ULNRC-3382

CALLAWAY PLANT  
DOCKET NUMBER 50-483  
MAIN FEEDWATER CONTROL AND BYPASS VALVES  
UNREVIEWED SAFETY QUESTION

PROPOSED FSAR CHANGES

FSAR Page 7.1-13  
Figure 7.2-1 (Sheet 13)  
Figure 7.2-1 (Sheet 14)  
FSAR Page 10.4-23  
Table 10.4-7  
Figure 10.4-6 (Sheet 1)

FIGURE 7.2.1  
FUNCTIONAL DIAGRAMS  
(FEEDWATER CONTROL  
AND ISOLATION)

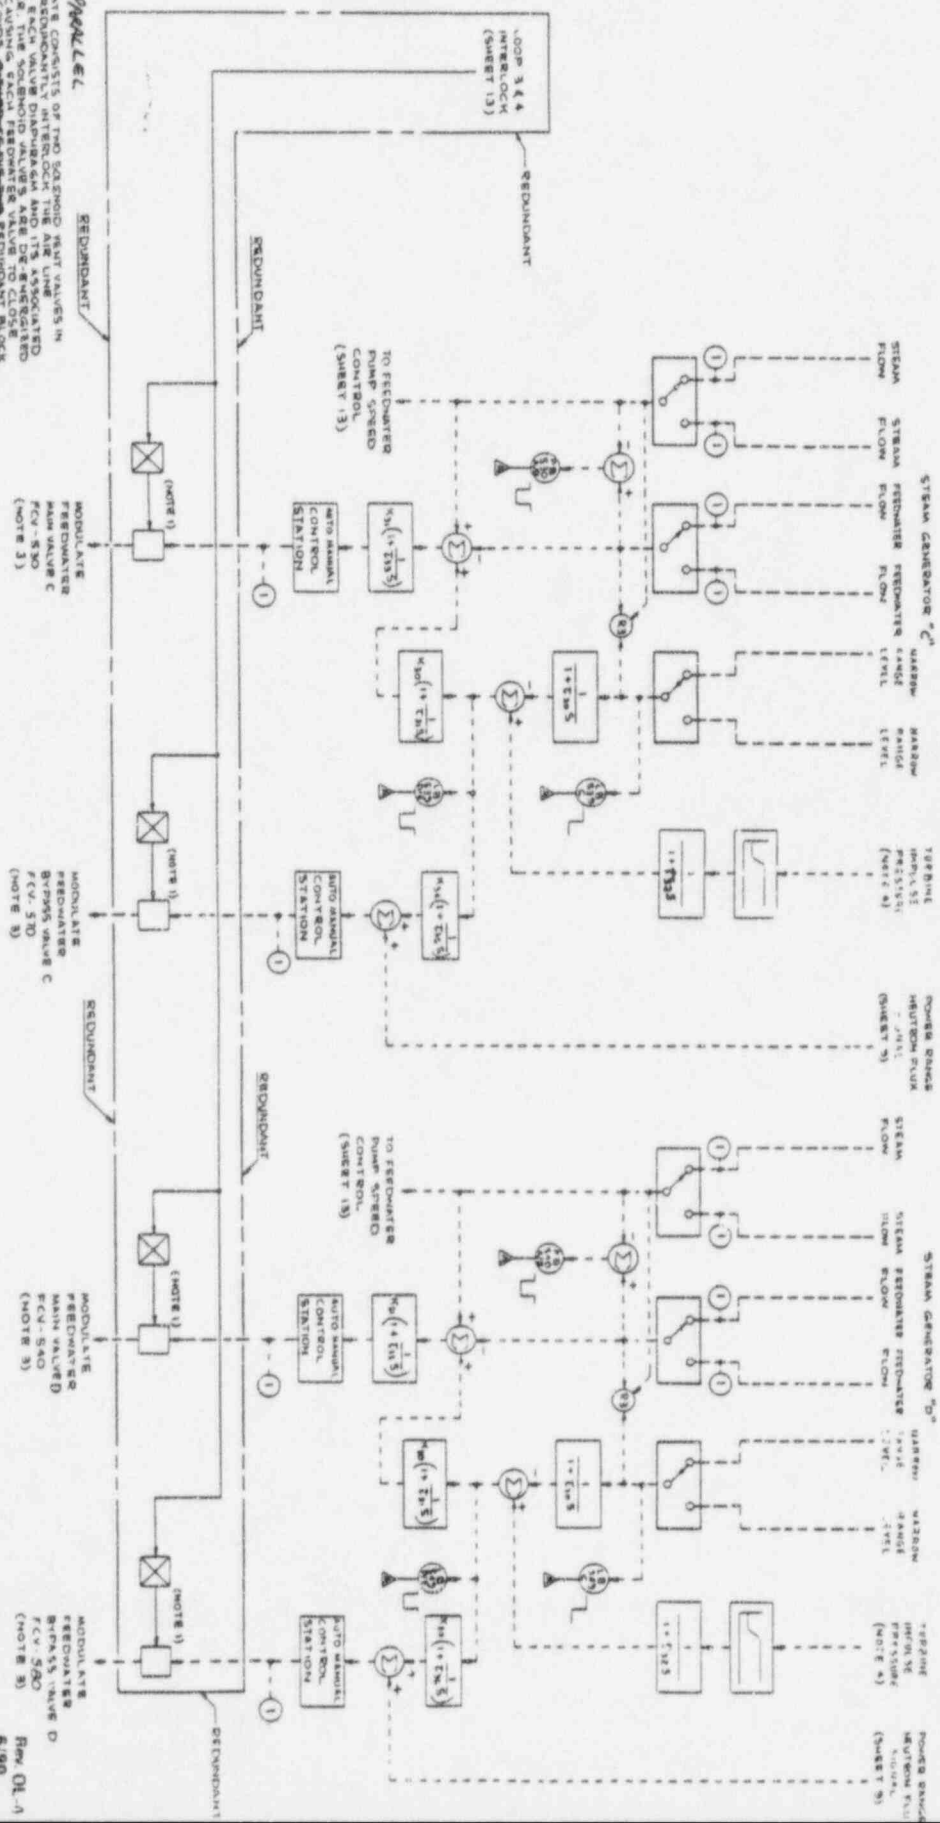
In the event of a secondary cycle pipe rupture inside the containment, the main feedwater control valve (and associated bypass valve) provide a diverse backup to the MFIV to limit the quantity of high energy fluid that enters the containment through the broken loop. For emergency closure, ~~either of two separate~~ solenoids, when de-energized, will result in valve closure. Electrical solenoids are energized from separate Class 1E sources. *both*

TABLE 10.4-7

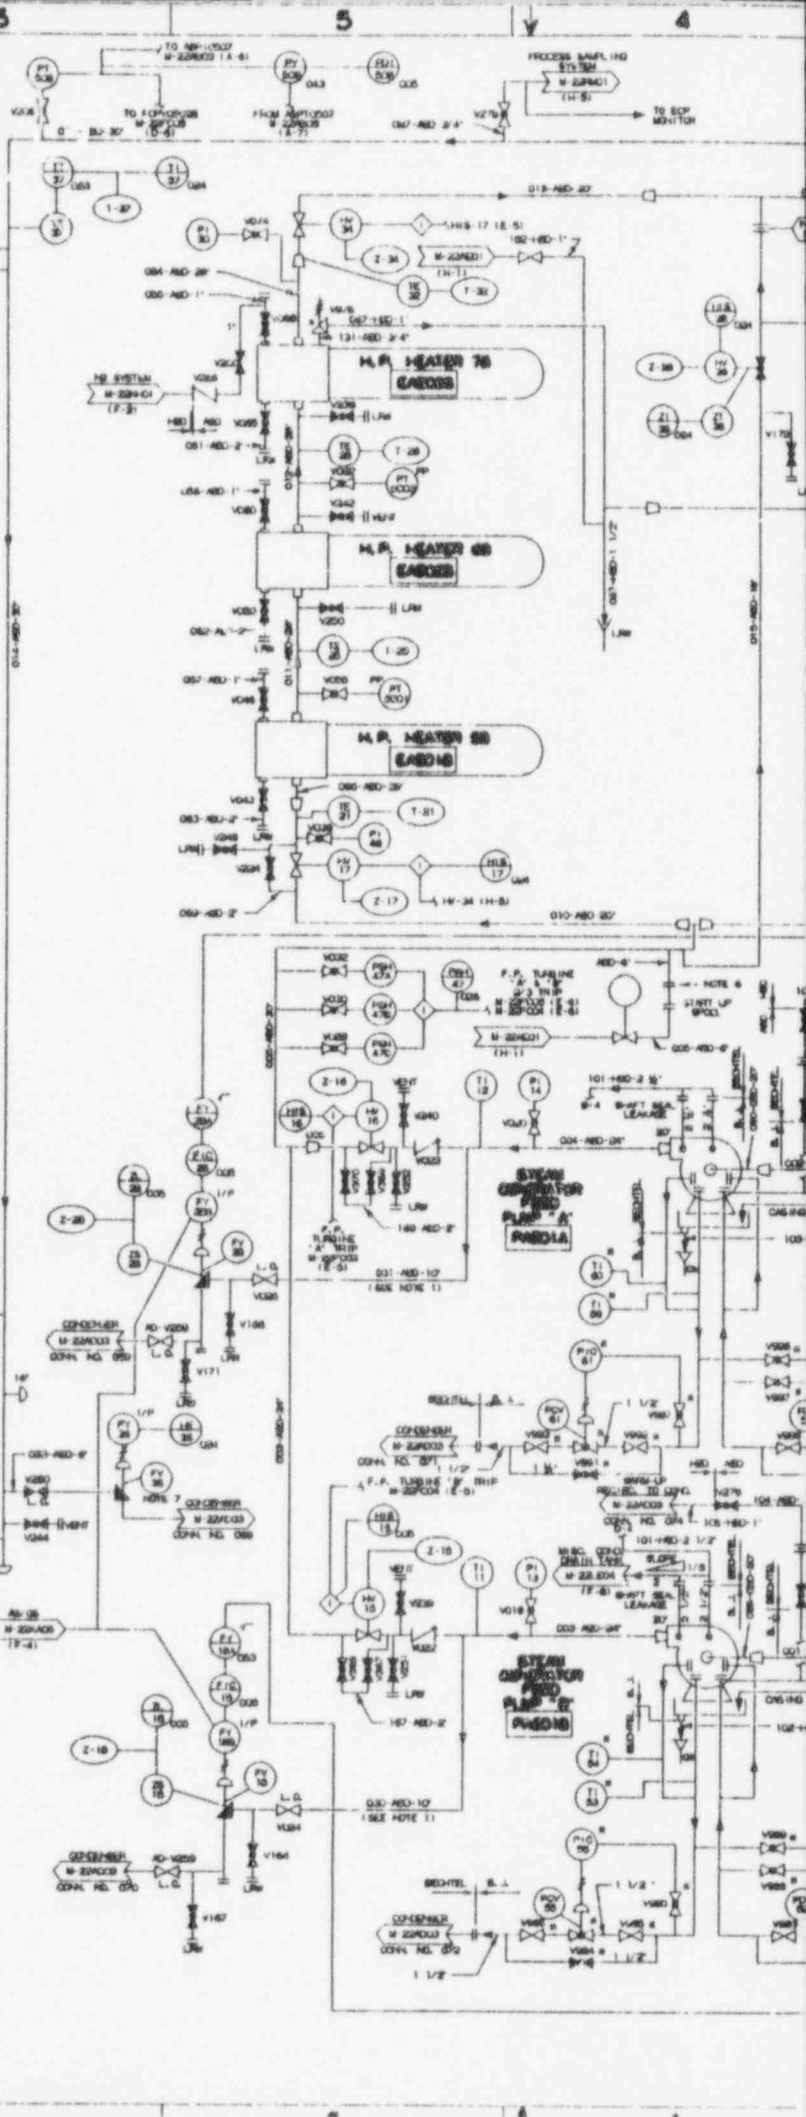
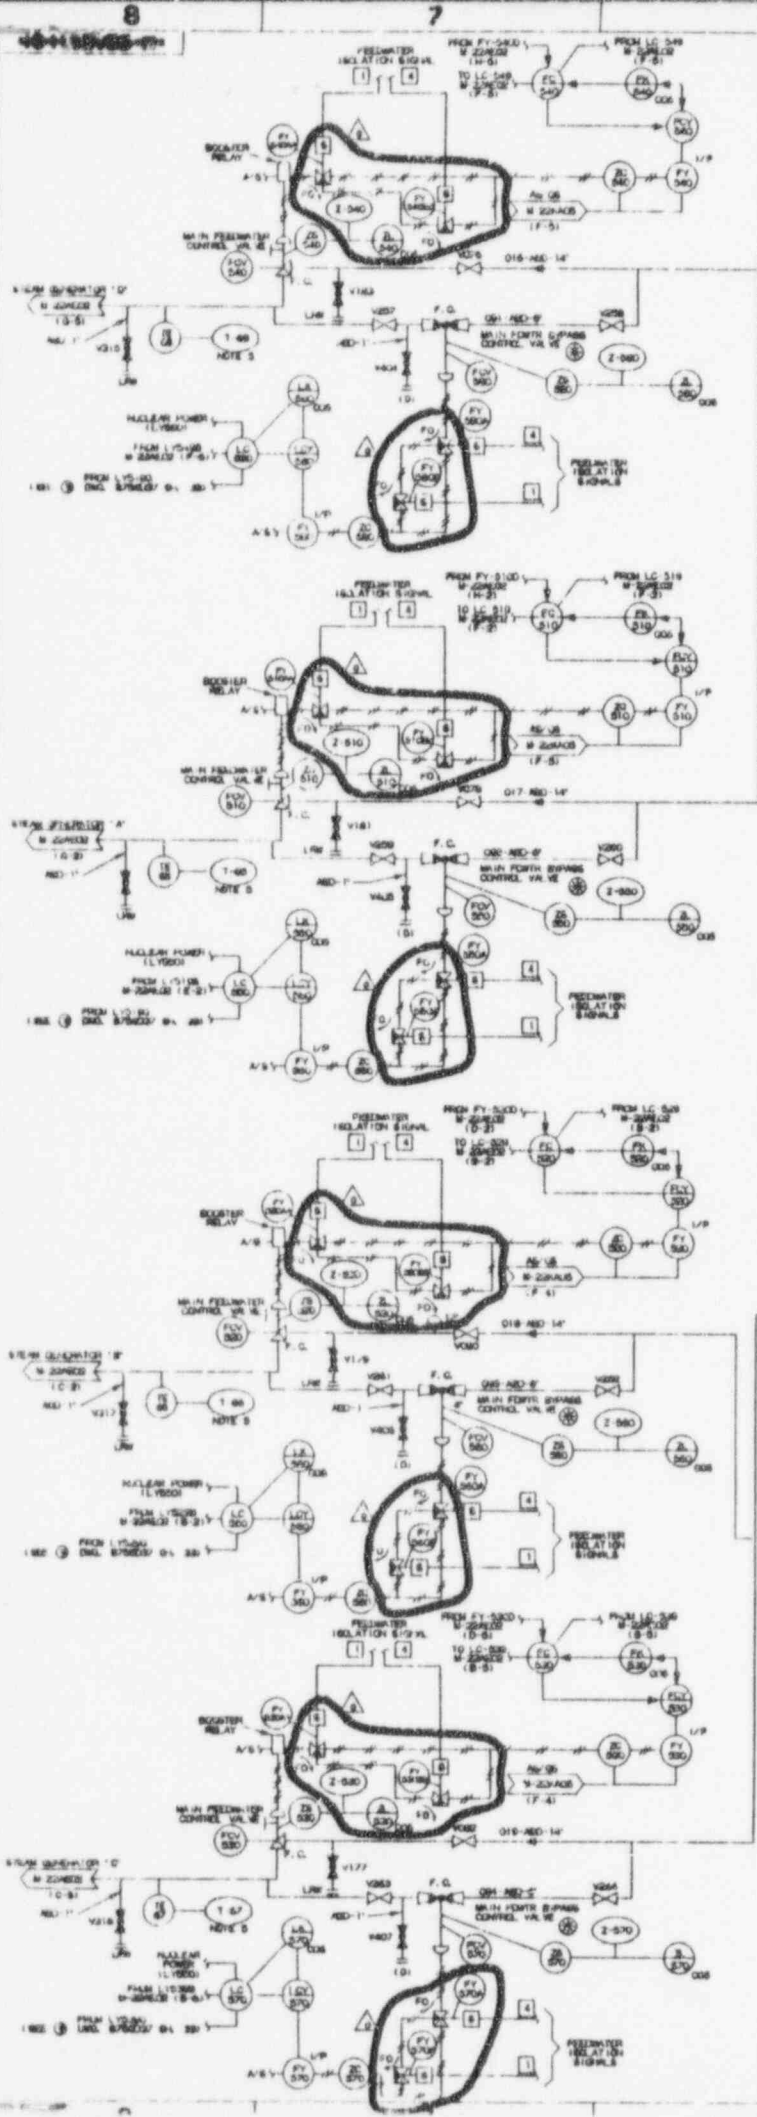
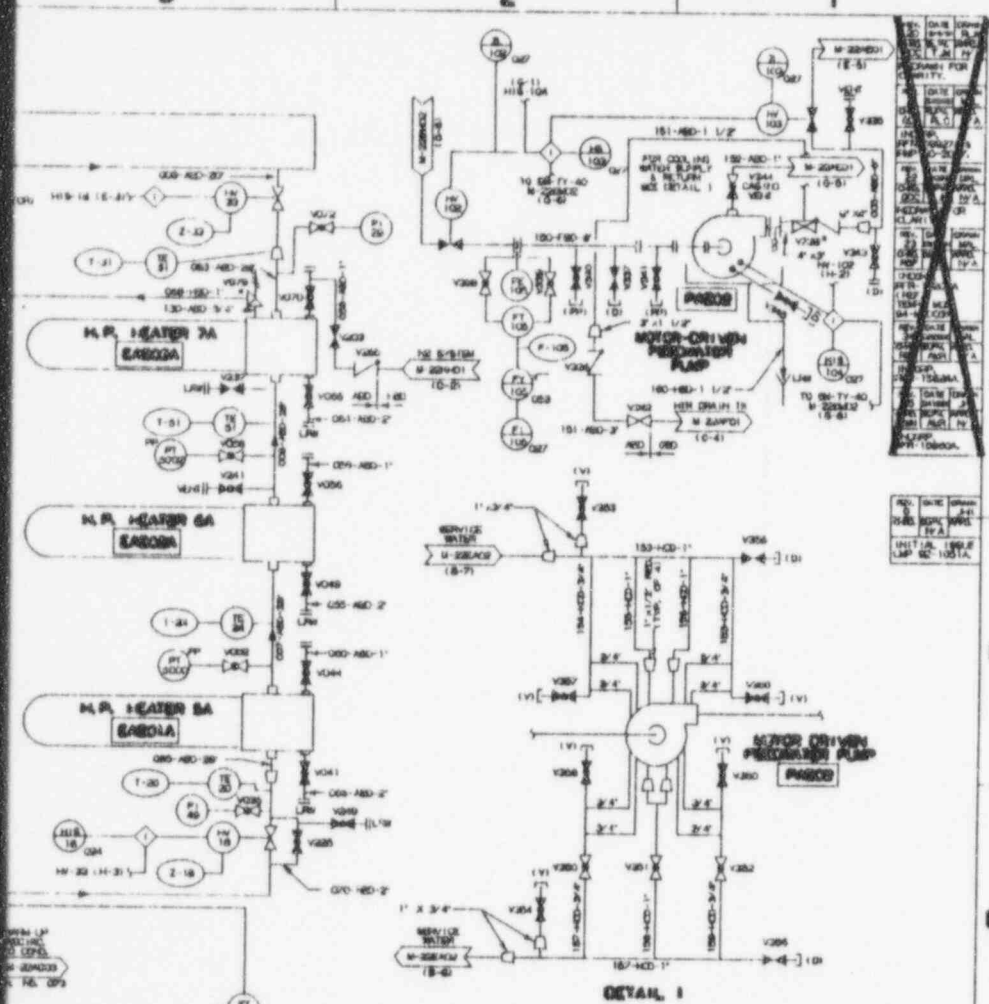
<u>Component</u>	<u>Failure</u>	<u>Comments</u>
Main feedwater control valve (MFCV) (1)	Valve fails to close upon receipt of automatic signal (FIS)	MFIV will close, providing adequate isolation to limit high energy fluid addition
	Loss of power from one power supply	Valve fails <sup>as is</sup> <del>closed</del> upon loss of either train of power; however, MFIV can be closed providing adequate isolation to limit high energy fluid addition.
Main feedwater bypass control valve. MFBCU (1)	Same as main feedwater control valve	Same as main feedwater control valve BBB 5/16/96
Main feedwater isolation valve (MFIV)	Valve fails to close upon receipt of automatic signal (FIS)	MF control valve and MF check valve close as required to isolate.  The MF control valve (and bypass control valve) serve to limit the addition of high energy fluid into the containment following a main feedwater line rupture inside the containment or a main steam line break.

Loss of power from one power supply	Valve fails closed upon loss of either train of power
Main feedwater check valve	Valve fails to close	MFIV will close, providing adequate isolation
